SITE SUPPLEMENTAL INSTRUCTION

PROJECT: Forestside Estates
Attmar & Palleschi Drive
Brampton, ON

SITE SI NO. M-7

PURPOSE: To revise make-up air risers to suit space requirements & City Permits comments.

DRAWN MC	CHECKED LM	SCALE 1:50
DATE MAY, 2019	PROJECT 18-017	DRAWING M-15A OF -

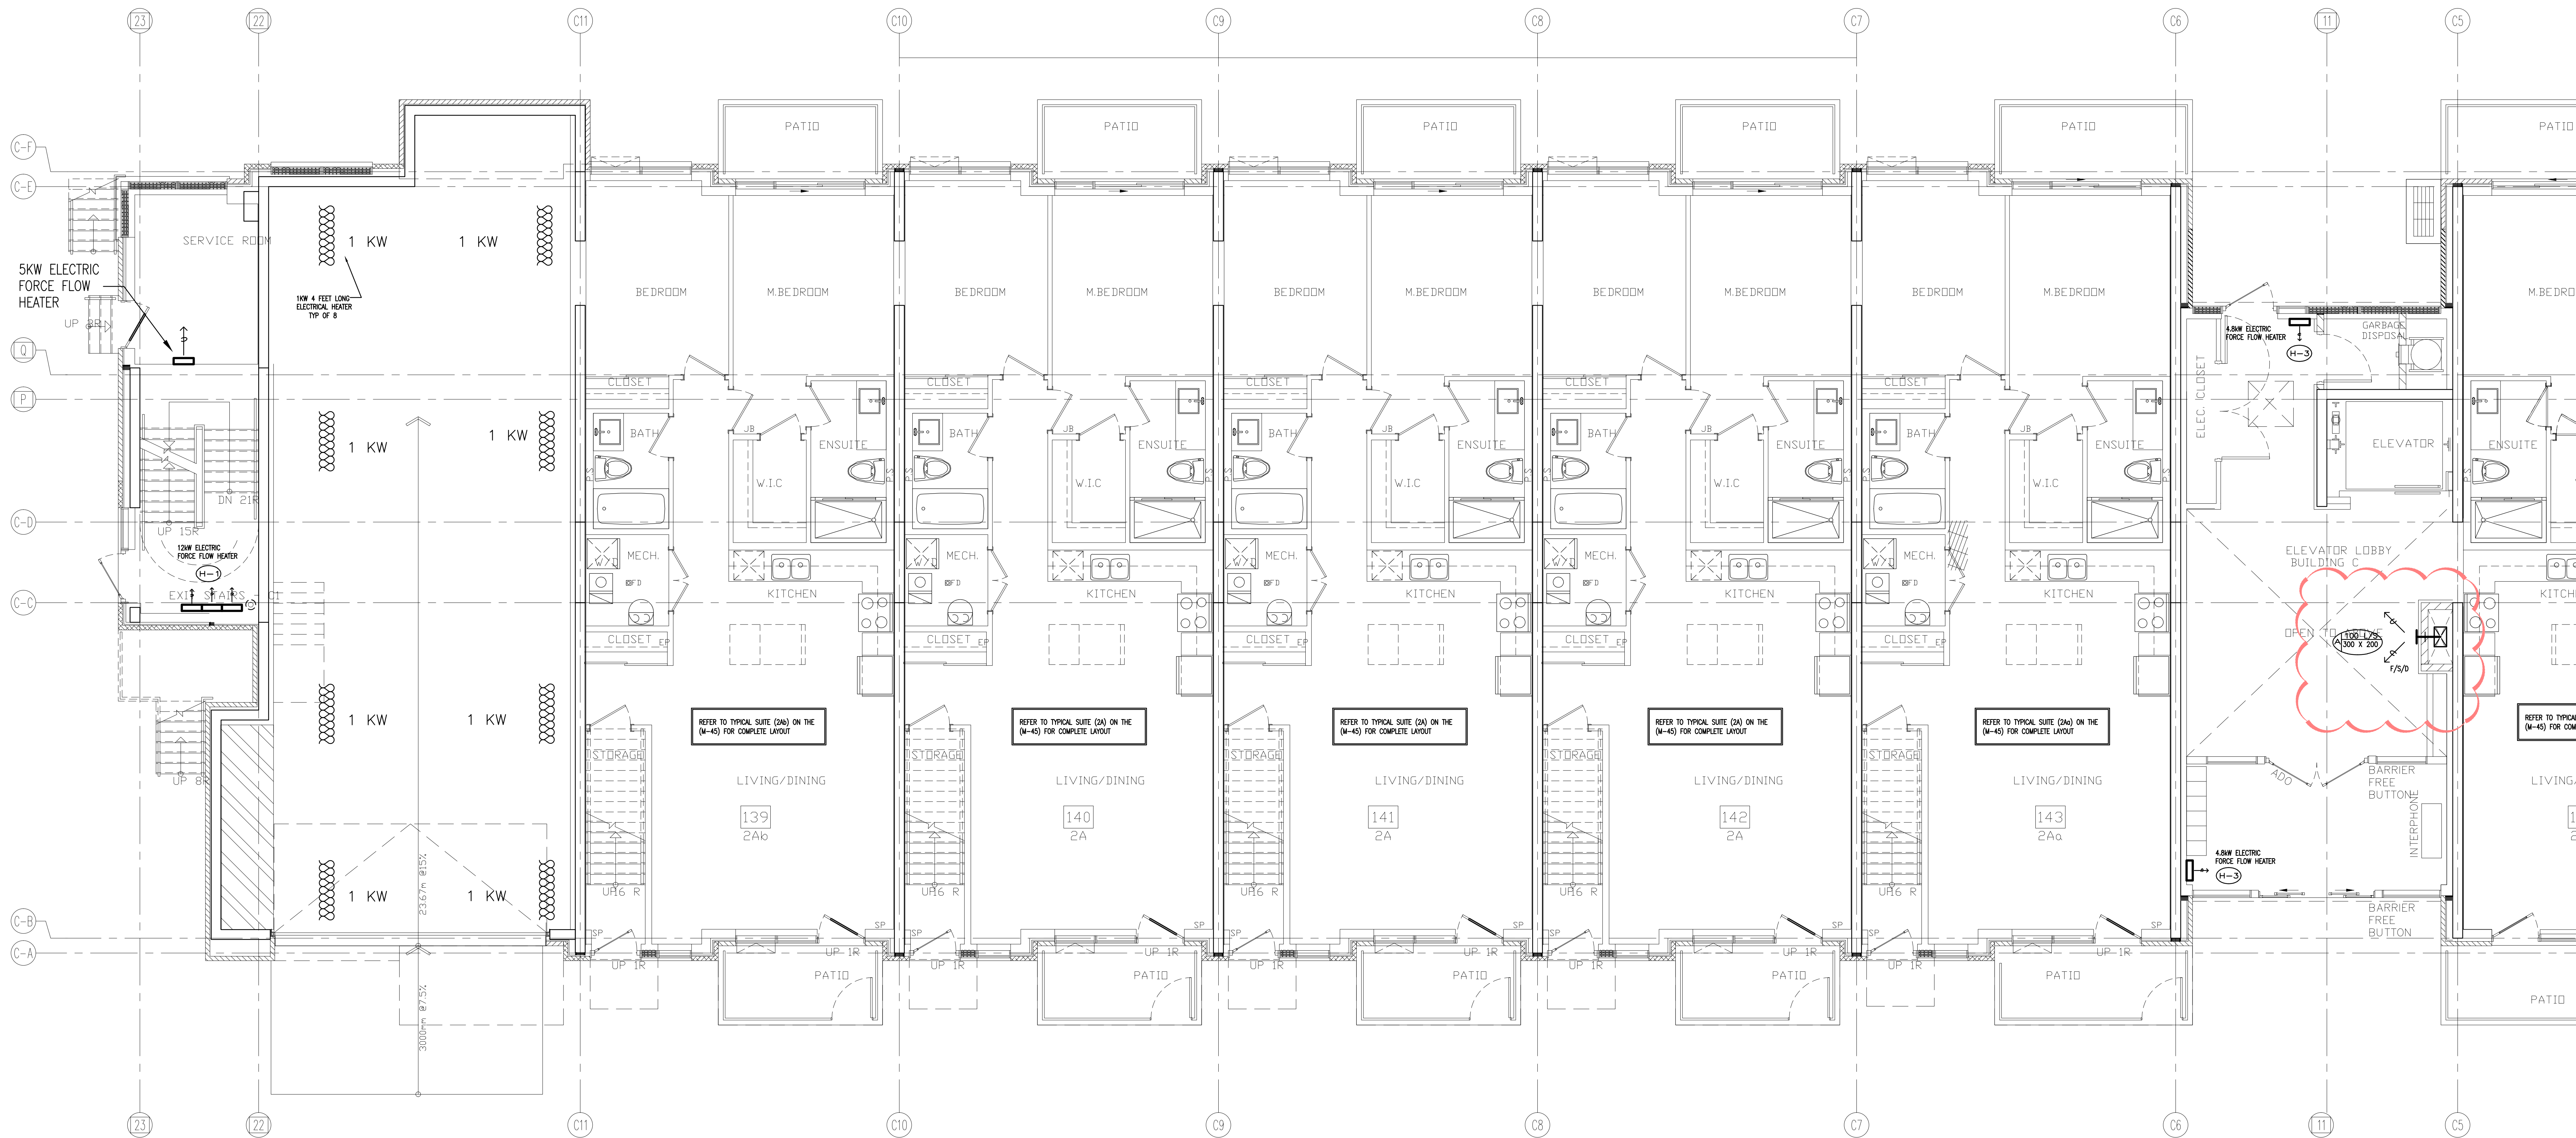
6.1 Clarify: Make-up air riser.

DRAWN	CHECKED	SCALE
MC	LM	1:50
DATE	PROJECT	DRAWING
MAY, 2019	18-017	M-17A
		OF

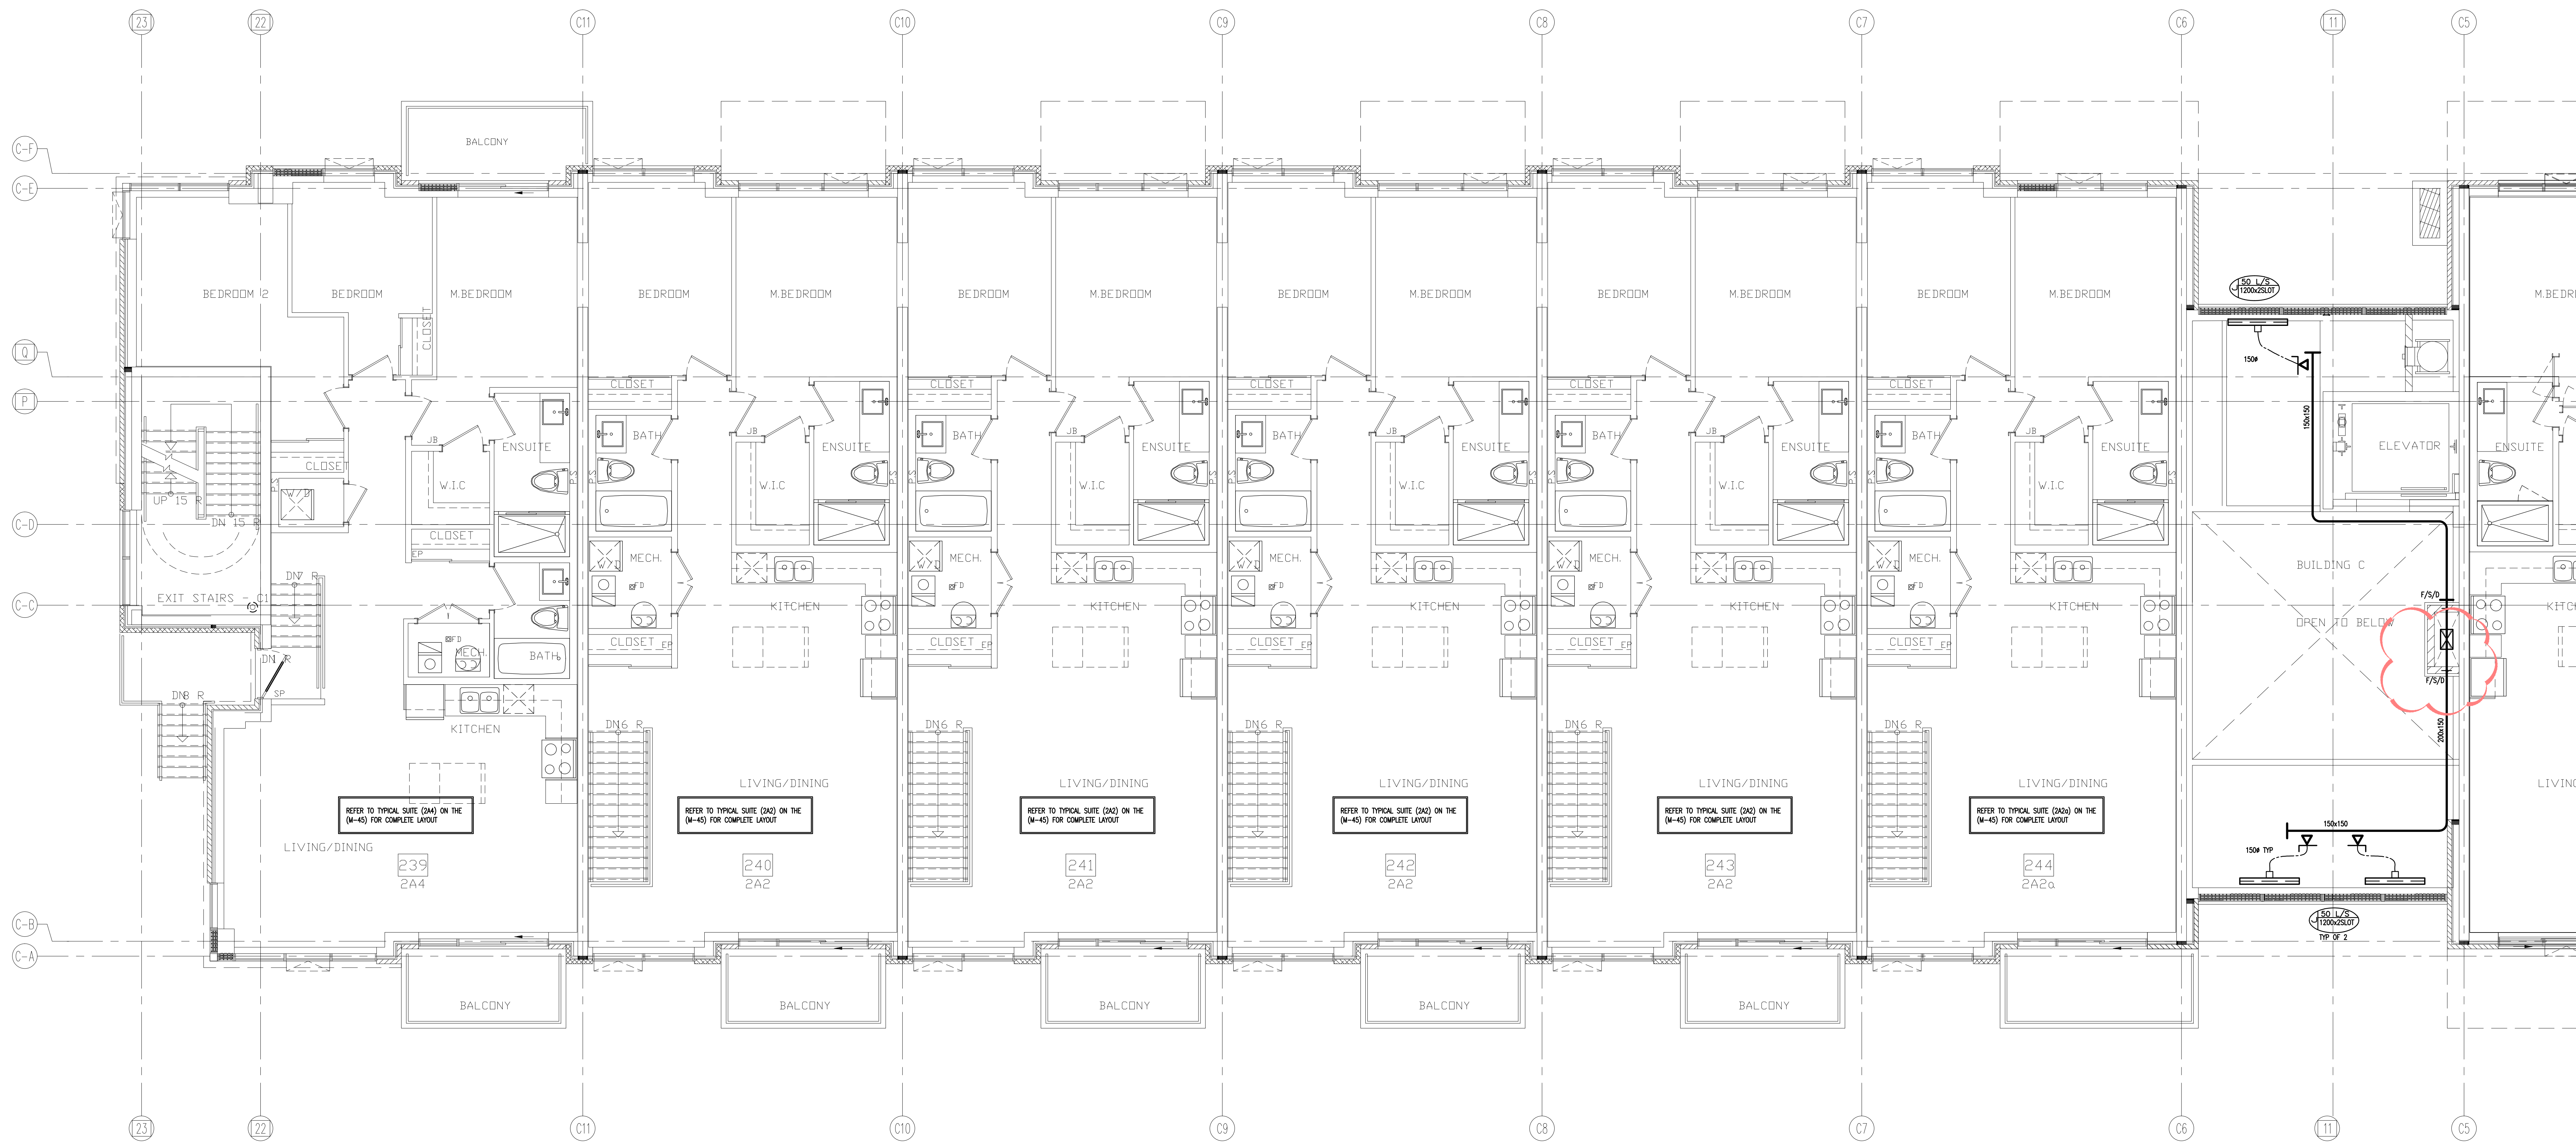
7.1 Relocate: Make-up air riser. .
Locate make-up air riser 600mm.
Back from face of corridor wall (cut floor).

DRAWN MC	CHECKED LM	SCALE 1:50
DATE MAY, 2019	PROJECT 18-017	DRAWING M-19A OF -

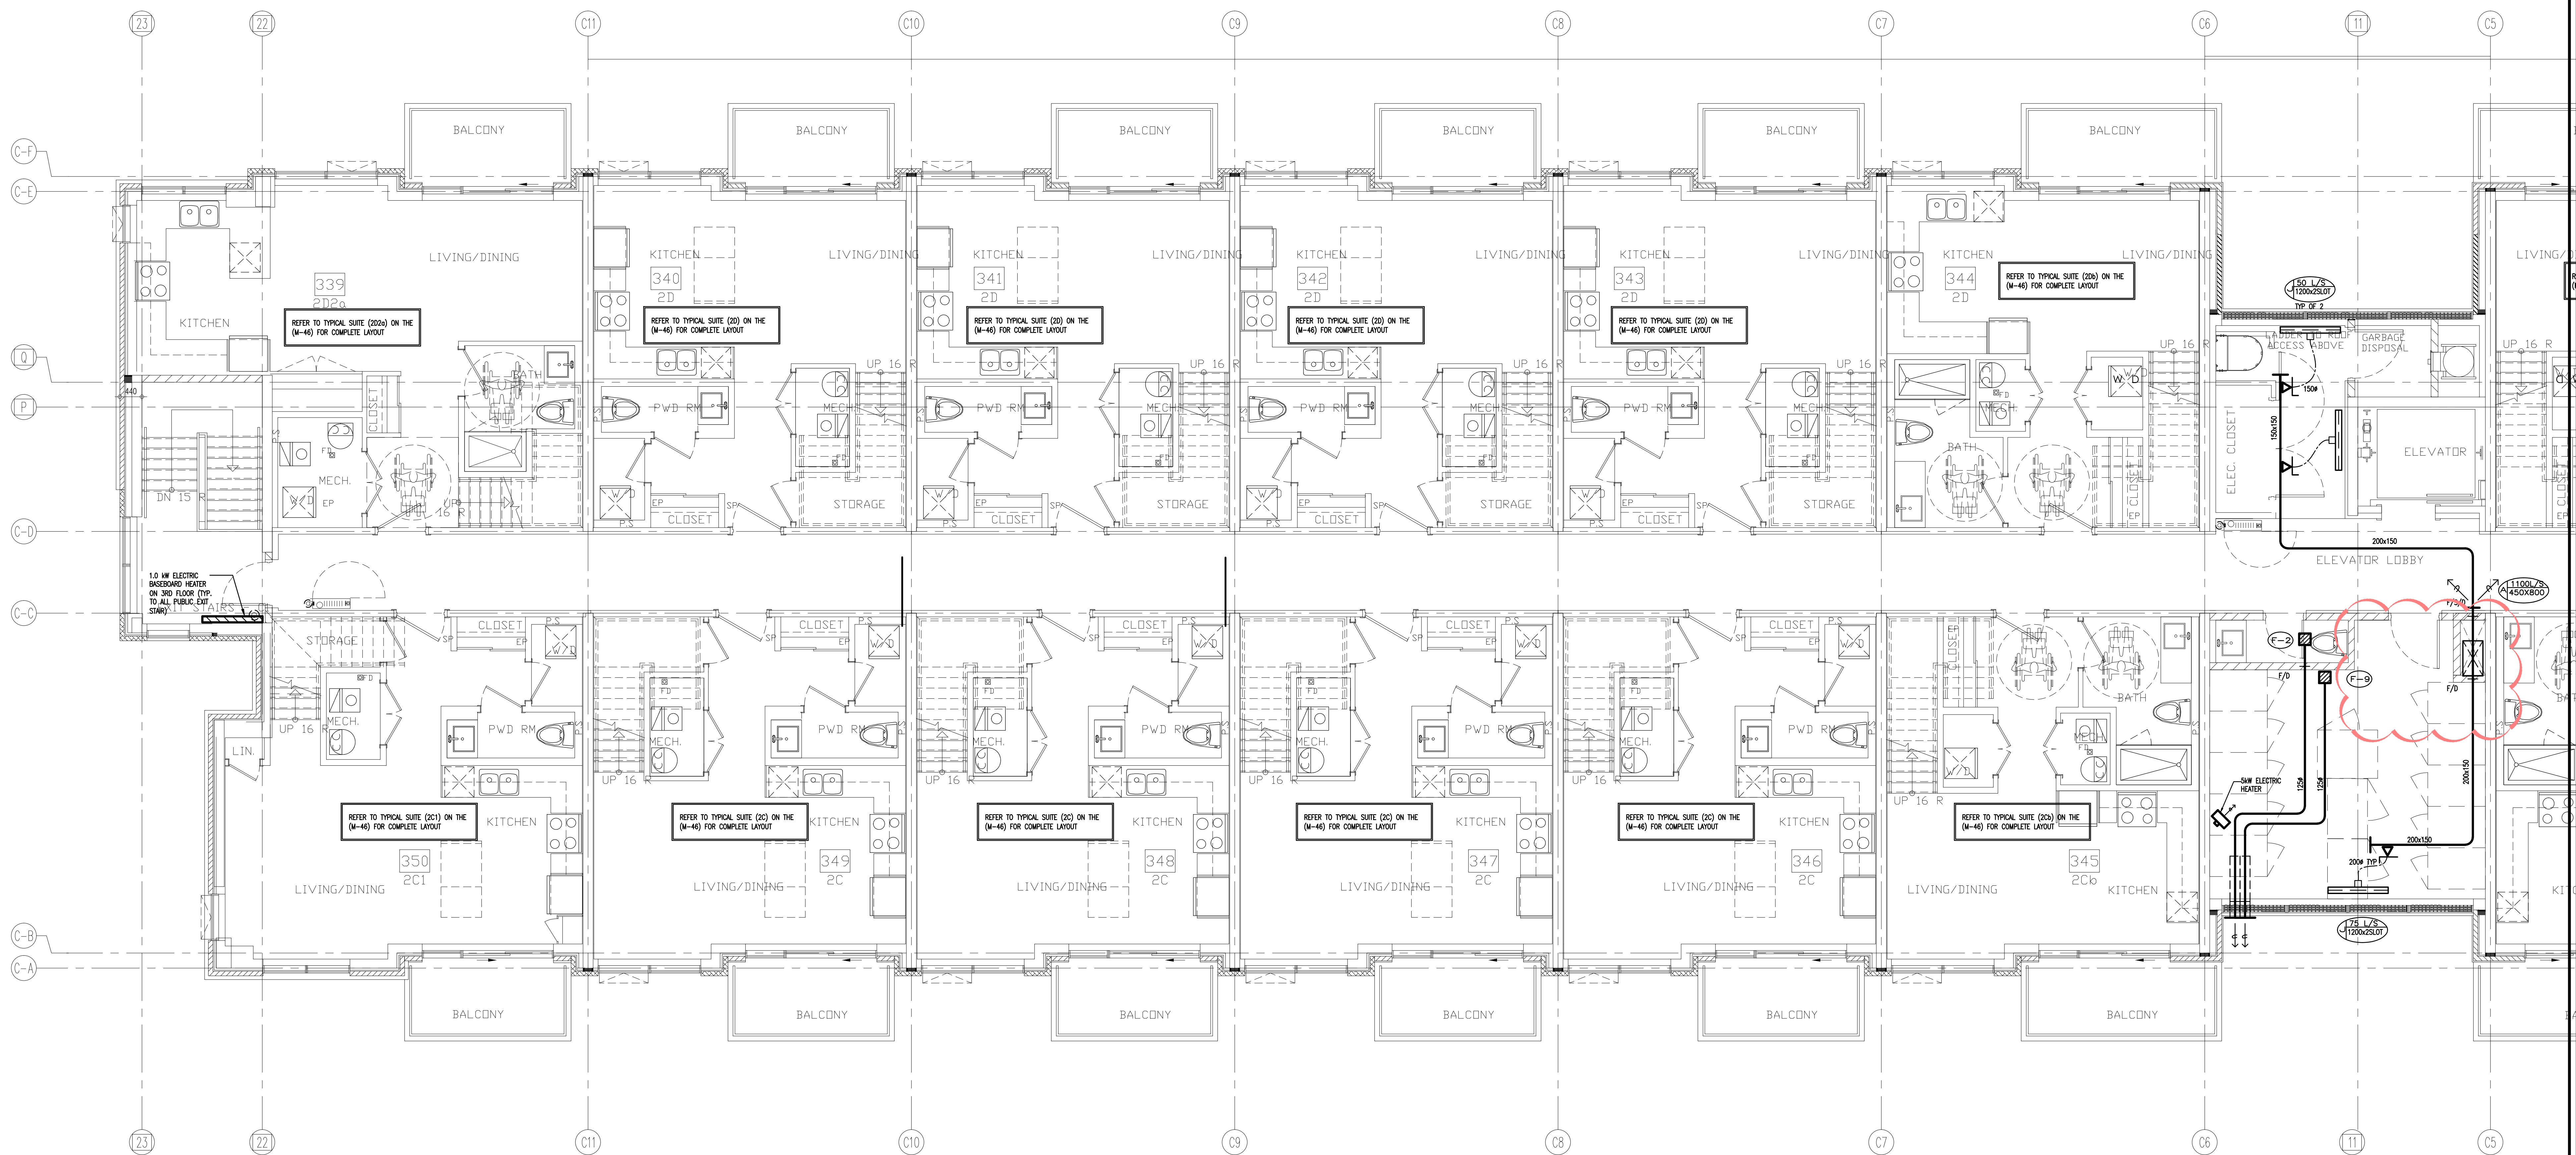
8.1 Relocate: Make-up air riser.
Locate make-up air riser 600mm.
Back from face of corridor wall (cut floor).
